# CERTIFICATE OF APPROPRIATENESS PLACARD

602 E LANE STREET

# Raleigh Historic Development Commission – Certificate of Appropriateness (COA) Application

**From:** Laura Malahias <laurajost@gmail.com>  
**Sent:** Monday, June 11, 2018 12:37 PM  
**To:** Robb, Melissa  
**Cc:** Tully, Tania; Kinane, Collette; leon malahias  
**Subject:** Re: COA Meeting - Thursday, May 24, 2018 - 064-18-CA (602 E Lane) - Initial Staff Comments  
**Attachments:** Malahias updated patio drawings.pdf

**Proposed style of New Fence and Lattice**

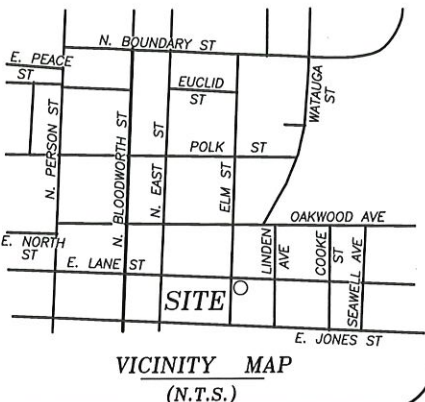
HEIGHT ? FENCE DESIGN MODIFIED TO MATCH EXISTING w/ NEW 42" TALL SECTION

← FENCE STYLE CHANGED TO MATCH EXISTING

602 E Lane St neighborhood context

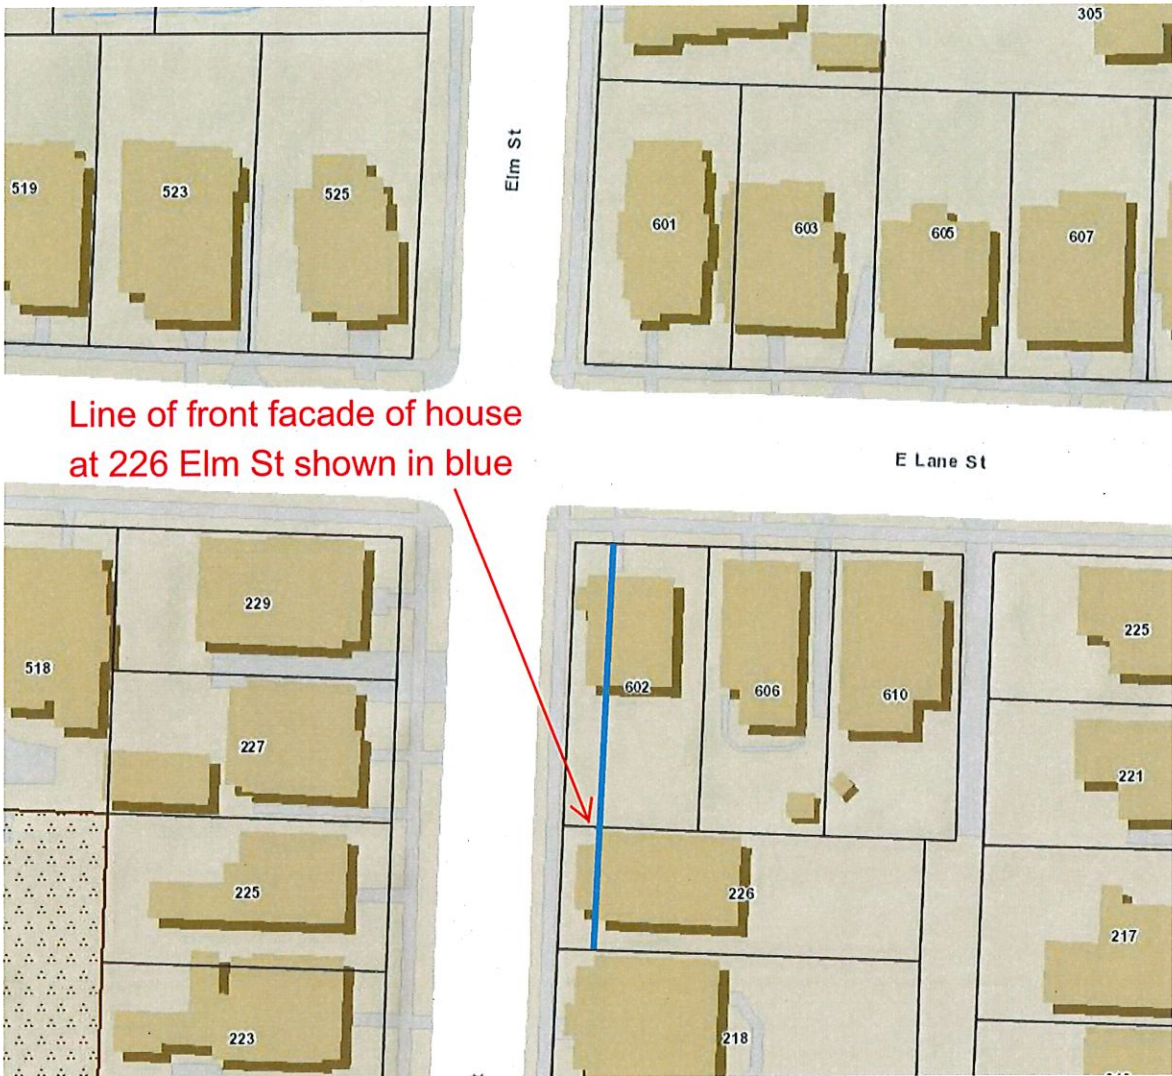
1. Please provide a site plan of your property that is zoomed out slightly from the landscaping site plan to show the relationship of your house and the neighbor's house at 226 Elm St. It will be important that none of your new, taller landscape elements (such as the bike shed and the taller fence) are closer to Elm St than the front of their house sits to Elm St.

6. Please provide a site plan of your property that is zoomed out slightly from the landscaping site plan to show the relationship of your house and the neighbor's house at 226 Elm St. It will be important that none of your new, taller landscape elements (such as the bike shed and the taller fence) are closer to Elm St than the front of their house sits to Elm St.

**Does 'front of the house' refer to the line of the front porch or the house facade? It's the front wall of the neighbor's house. I've created a sample of the plan view I requested (attached). Since you are on a corner lot, the relationship of your house/landscaping/accessory buildings/fence is important to both your neighbors at [606 E Lane St](#) and at 226 Elm St. The blue line that's in the attached document shows approximately where the front wall of the 226 Elm St house sits in relationship to the your house and yard. Generally, anything taller than a 42" fence needs to be east of that line. (Of course this does not apply to the replacement of your existing fence with a fence of the same height in the same location.) So when you decide to construct your bike shed it must be east of that line.**

4/26/18 SAMPLE PROVIDED TO APPLICANT

Line of front facade of house  
at 226 Elm St shown in blue

Note: The small porch addition shown on the west side of the house at 602 E Lane St is no longer there. It was removed during a rehabilitation project in 2017.

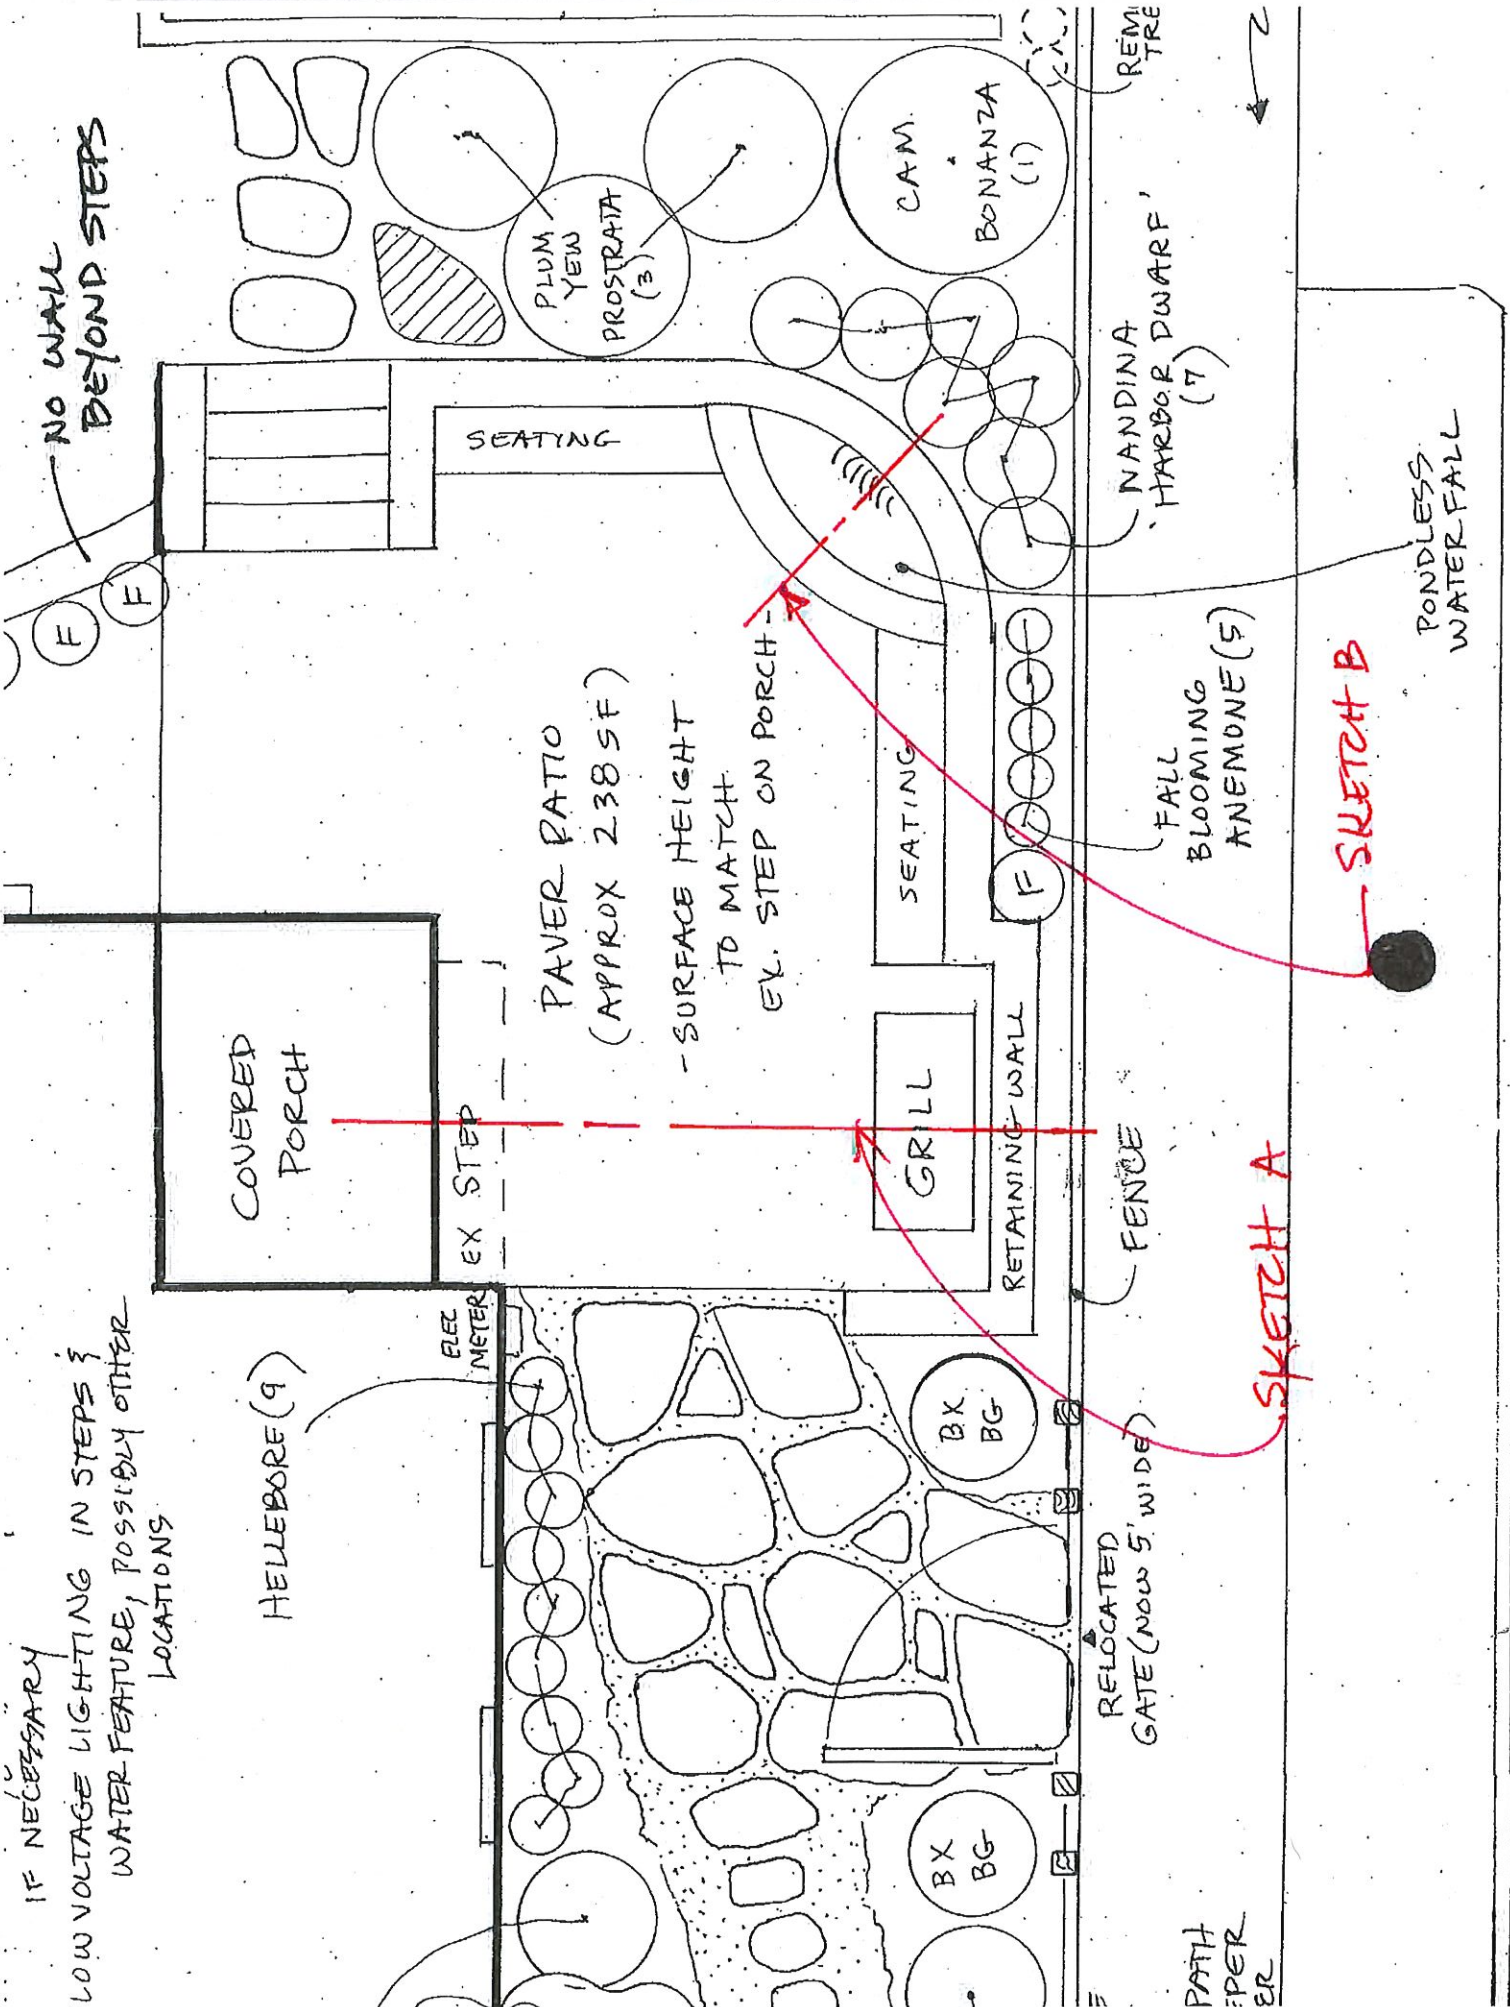
2. Please provide more information about the retaining walls, patio, stepping stones and rear steps. What are the materials? Please provide more specific information and color photos of the materials. Also, please provide scaled elevation and section drawings of the retaining walls and stairs with dimensions noted. This will show them both from a front view and from a side view, just like cutting through a layer cake and showing all the materials and where the ground level will be on both sides of the walls. Also, unless you are using brick, please provide evidence of the materials used on other COA-approved projects in Oakwood.

3. Please provide more information about the pondless waterfall. What are the materials? What is the design? Provide elevation and section drawings showing dimensions (see notes about the walls and stairs above), and photos if you have one you are replicating.

IF NECESSARY  
LOW VOLTAGE LIGHTING IN STEPS &  
WATER FEATURE, POSSIBLY OTHER  
LOCATIONS

NO WALL  
BEYOND STEPS

Landscape Plan For:  
**LAURA & LEON MAHAHAKS**  
 602 E. LANE ST  
 RALEIGH, NC 27604

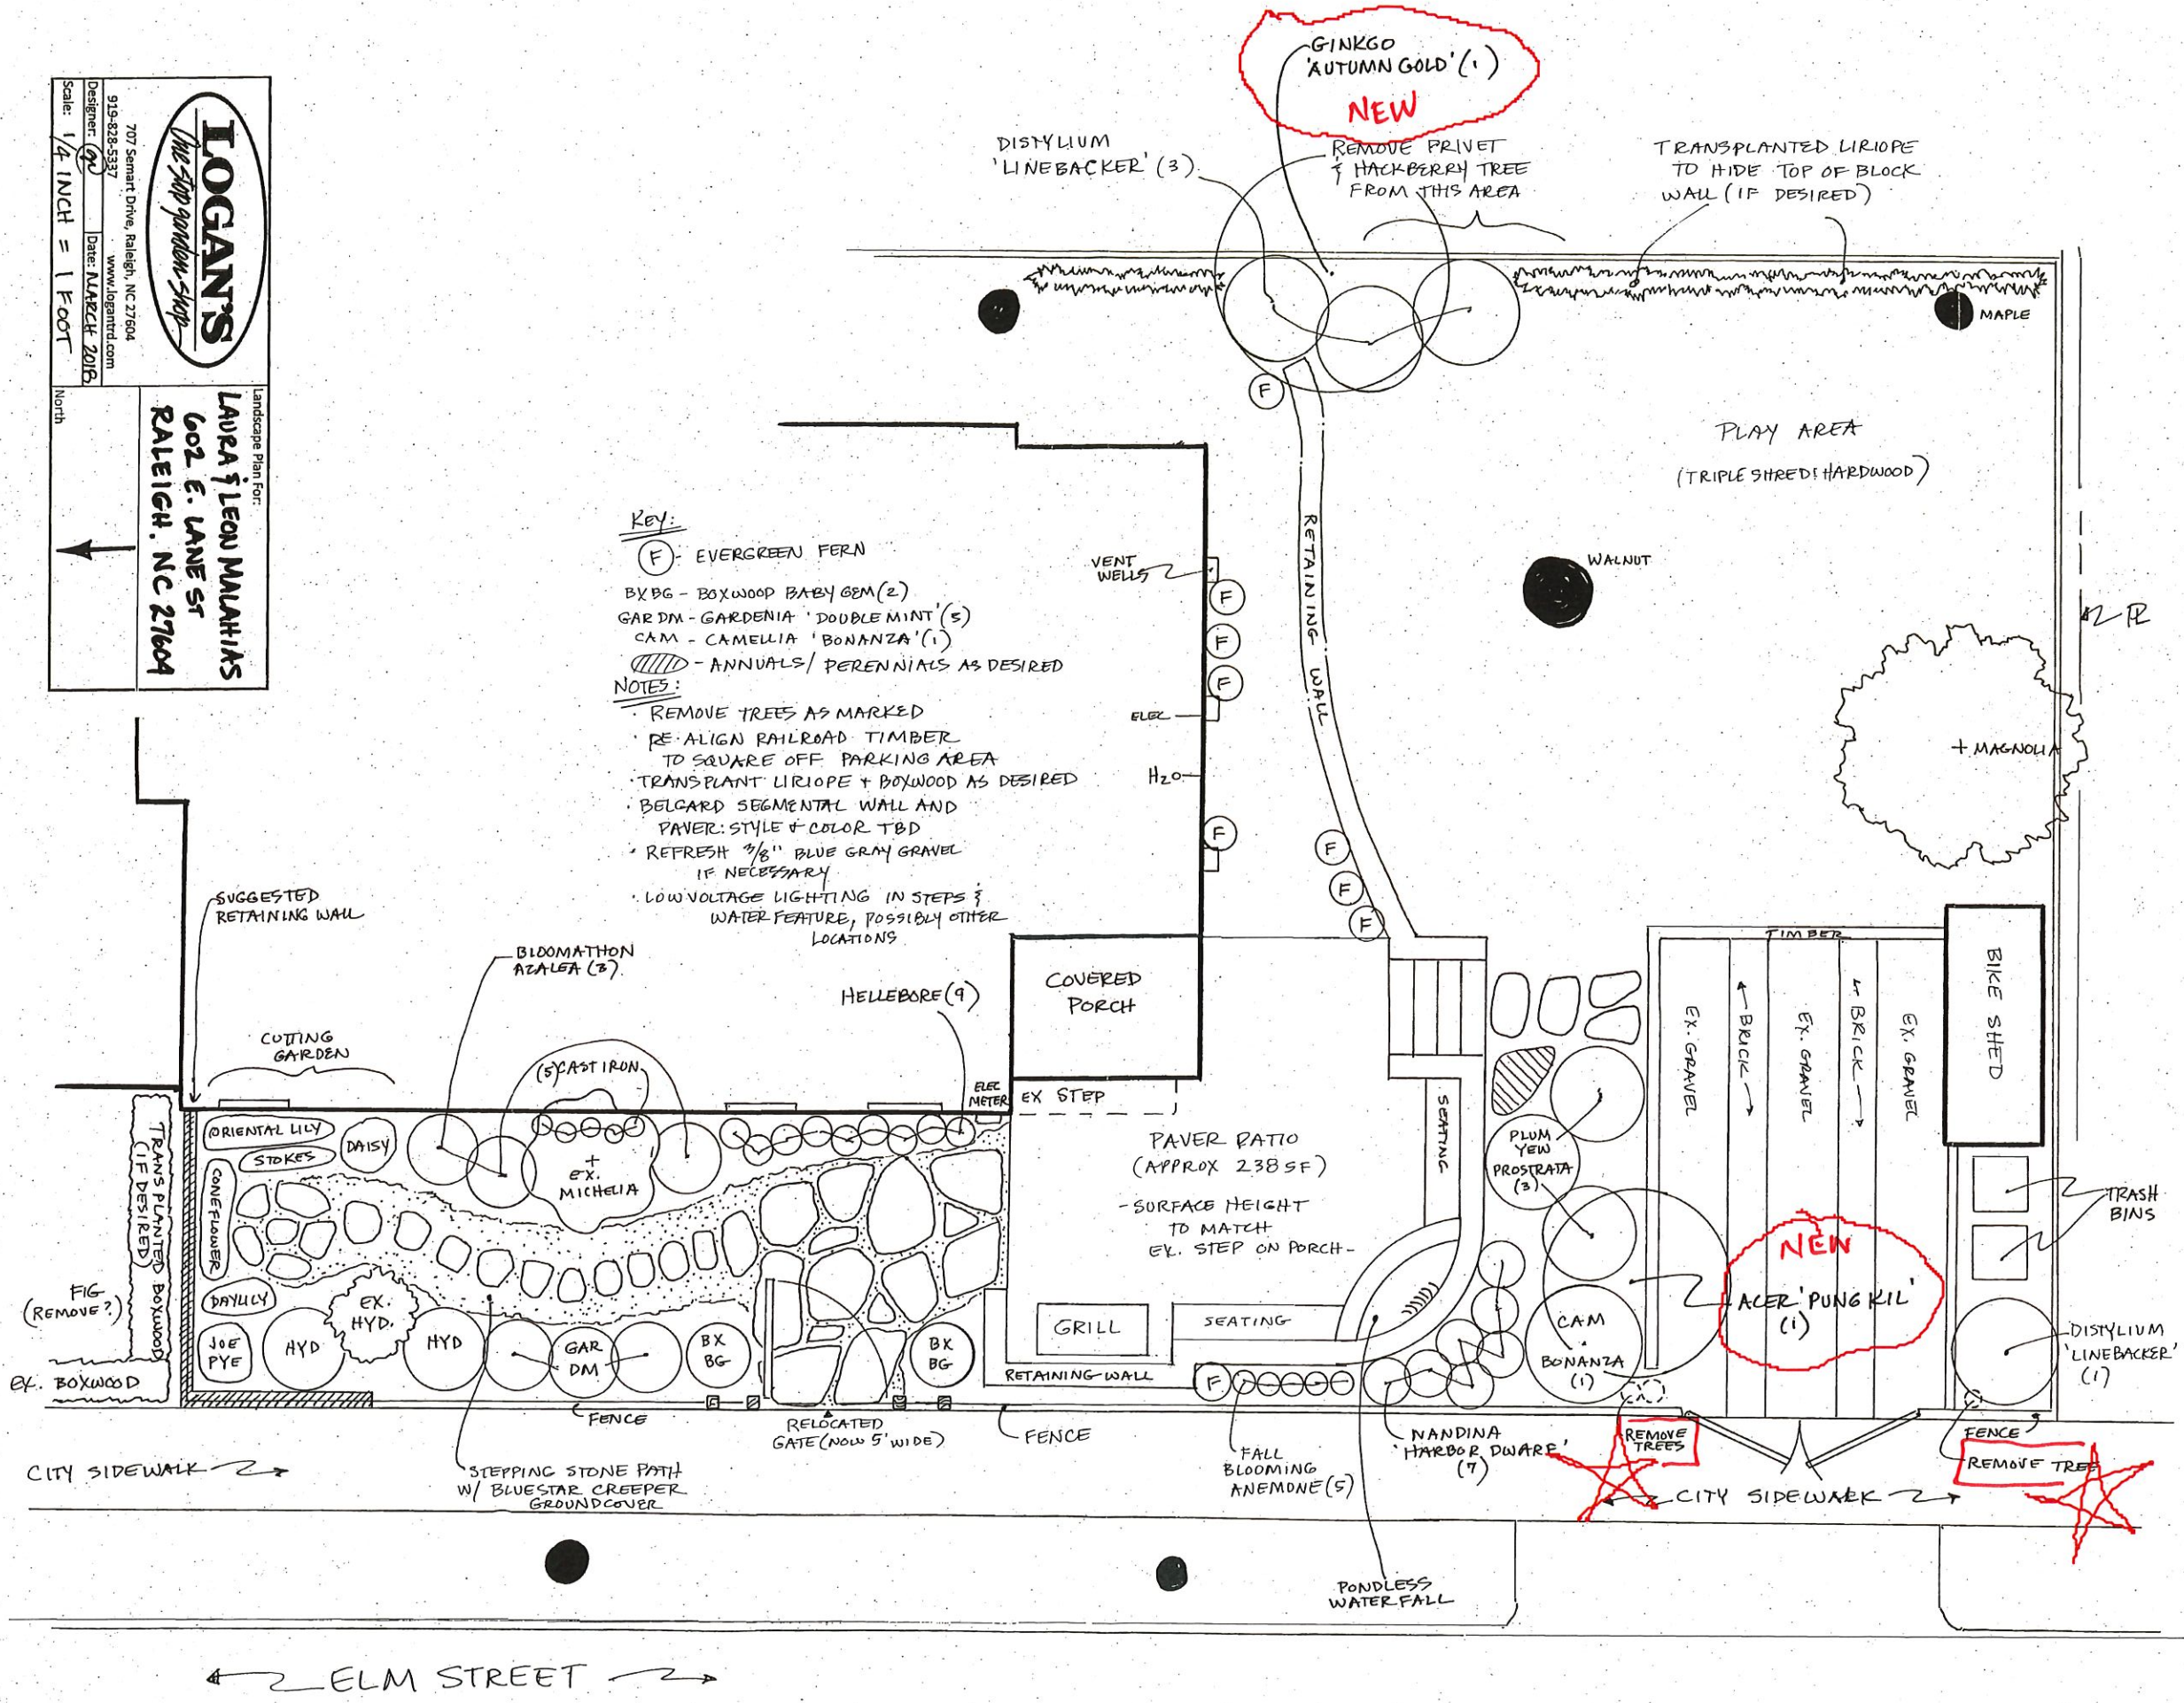
Thanks for your response Melissa. I'm attaching the landscaping plan with annotations for the trees we plan to remove as well as replacement trees. The red circles are the new trees and the starred trees are the ones being removed.

4. Please provide a tree protection plan for the existing trees in the back yard. Since there will be a fair amount of ground disturbance during the landscaping project, your arborist can recommend the best methods to preserve the trees. Your tree protection plan should show the critical root zone and the diameter of the trees (dbh). The tree protection plan should be from an arborist certified by the [International Society of Arboriculture](#) or a licensed landscape architect.

#### 4. Figure One: Critical Root Zone Improvement Area

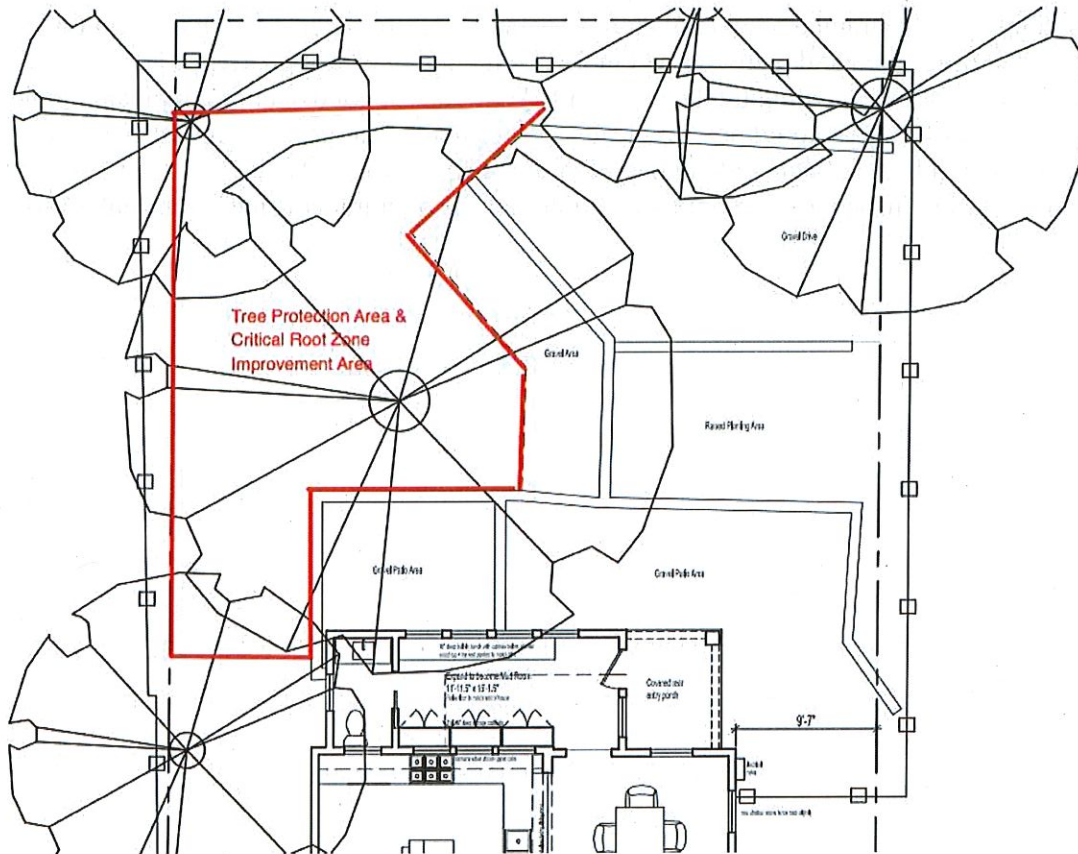
Thanks for the updated drawing and the tree protection plan. There are a few notes that should be shared with the contractor to protect the large walnut since you'll be digging nearby for the retaining wall:

One quick question with regard to the request for a tree protection plan. We had a plan generated for our recent construction work. Is the existing plan sufficient? It is attached. As a reminder, the only work that is near the walnut tree is to replace the original timber retaining wall with a brick wall.

- Hand excavate footings;
- Cut all roots larger than 1" cleanly with proper tools such as an axe, saw or loppers;
- Water entire area under tree during periods of drought for one year following construction (1" water/week);
- Install 4" mulch in protected area, placing plywood sheets over mulch in areas where construction traffic occurs;
- Do not store heavy materials in protected area
